**MAJOR PROJECT ASSESSMENT:
Dry Boat Storage and Marine Facility
James Craig Road, Rozelle Bay**

Environmental Assessment Report
Section 75I of the
*Environmental Planning and Assessment
Act 1979*

May 2007

Figure 7: Map demonstrating the area of a deeper water channel

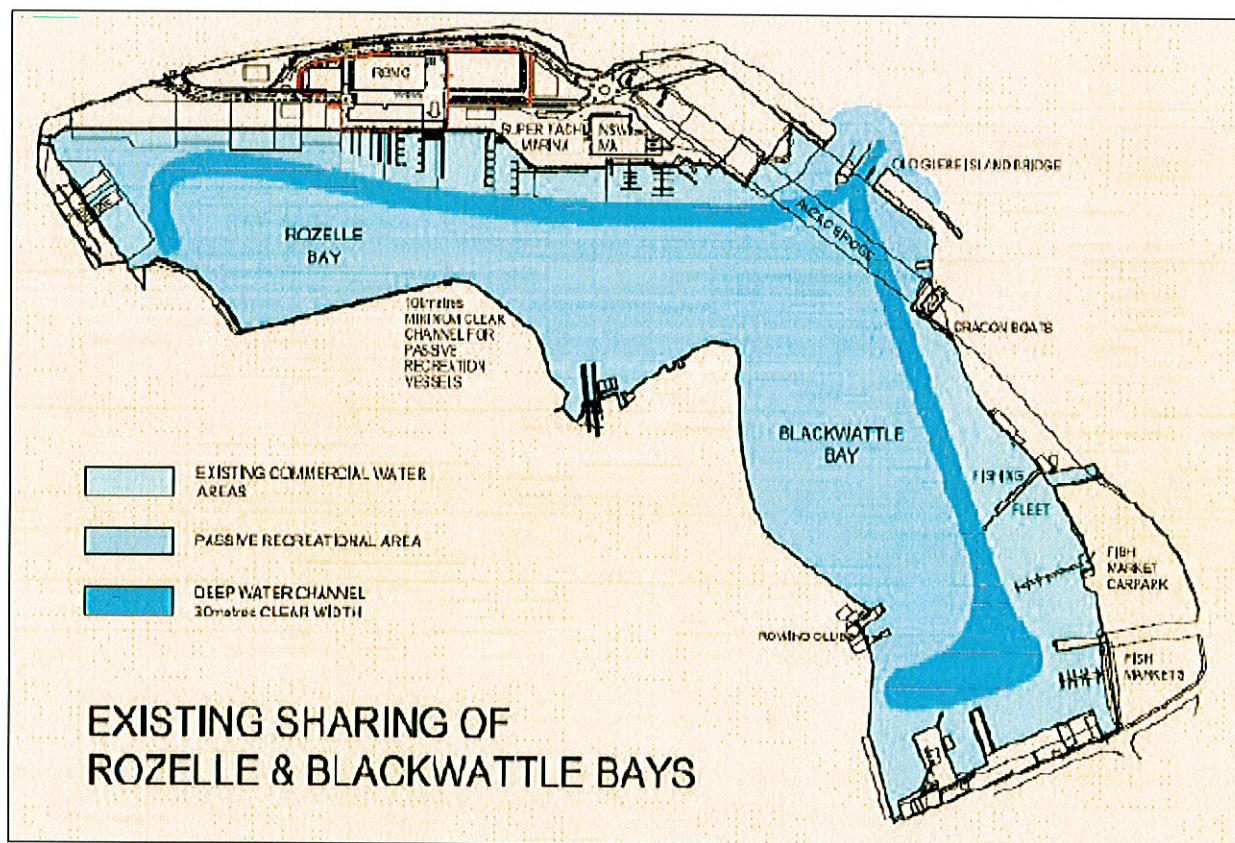
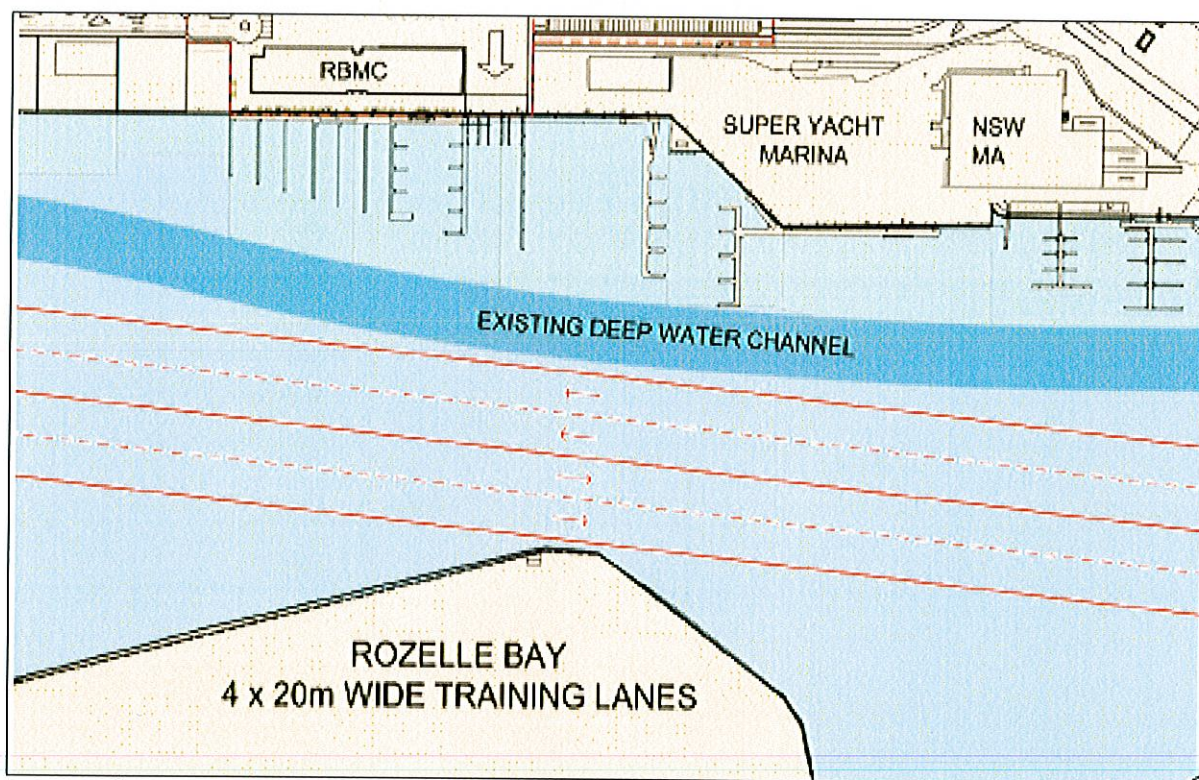
Concern has been raised that the increased boat movements from the proposed facility will result in less space on the waterway for training and other passive recreational uses.

The PPR has included a map, which shows an arrangement for the sharing of the Bays, whereby motorised vessels from the subject facility can gain access to Sydney Harbour via the 30 metre wide channel of deeper water within the Bay, taking a direct route to their destination, out beyond the Old Glebe Island Bridge.

The map also illustrates that there is a clear 100m wide channel (at low tide) along Rozelle Bay for the passage of passive recreational vessels. This space will allow for four 20 metre wide training lanes which are considered sufficient for passive recreational use, as illustrated in **Figure 8** below:

Nevertheless this is a matter that may need to be subject of further review once in operation as it does then introduce additional lines along which boats are travelling in opposite directions. It may therefore be preferable to maintain the established and standard maritime practice of boats travelling on the right side of the water within the Bay, resulting in all motorised and non-motorised boats travelling in the same direction, effectively in a one way loop around the bay.

Figure 11: Proposed Foreshore Access Management Plan

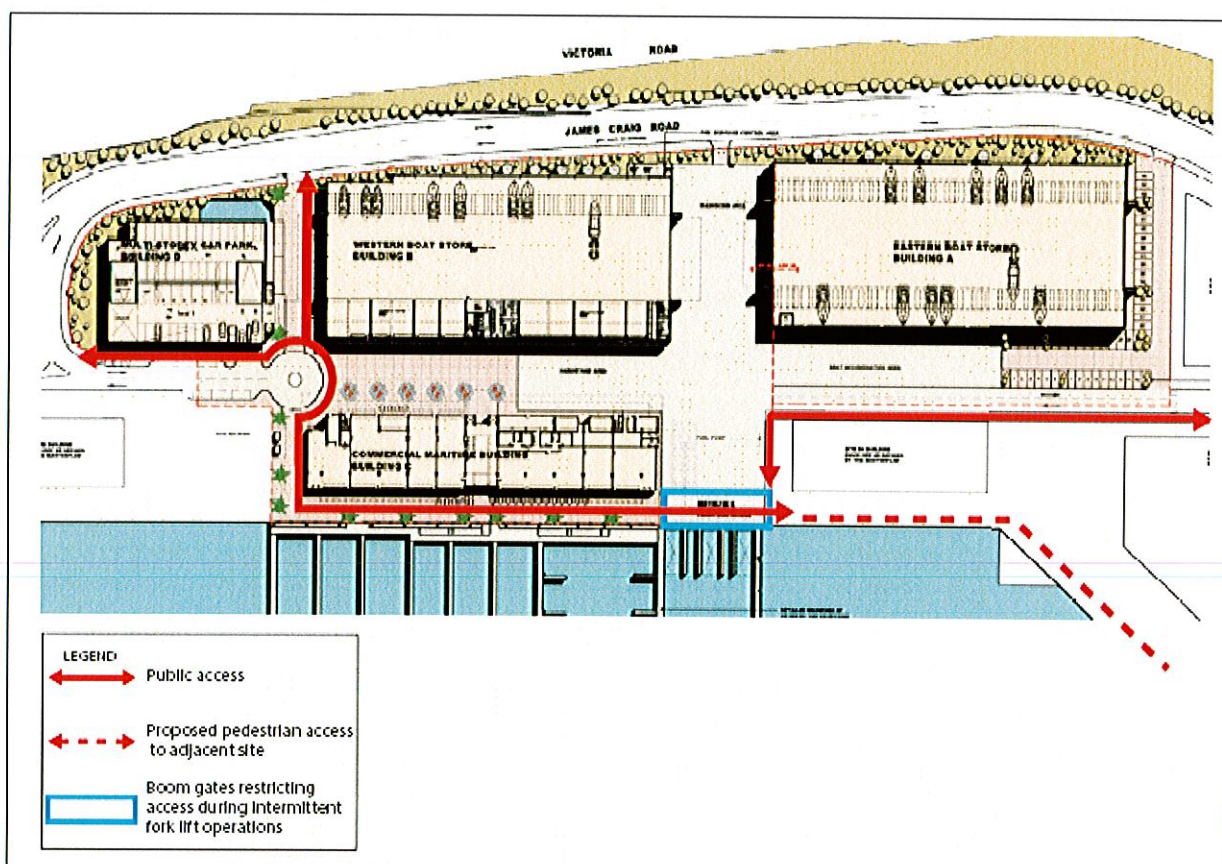
The only area of the site where foreshore access will be intermittently impeded is where the forklifts will be lifting boats in and out of the water. This is a necessary compromise with working harbour or commercial waterfront activities.

Nevertheless, in order to ensure public safety for pedestrian and cyclists, this area will be controlled with boom gates, which will be closed while a forklift is operating. During operations, members of the public will be required to wait behind the boom gates to allow for the safe passage of the forklifts, although access to pedestrians would also be available along the eastern and northern sides of the building to return back to the principle site entrance and carpark building.

However to ensure that the waiting times are minimised and to allow for unrestricted access outside of the hours of operation for the facility, a condition of approval has been recommended that will require a Public Access Foreshore Management Plan be prepared and submitted.
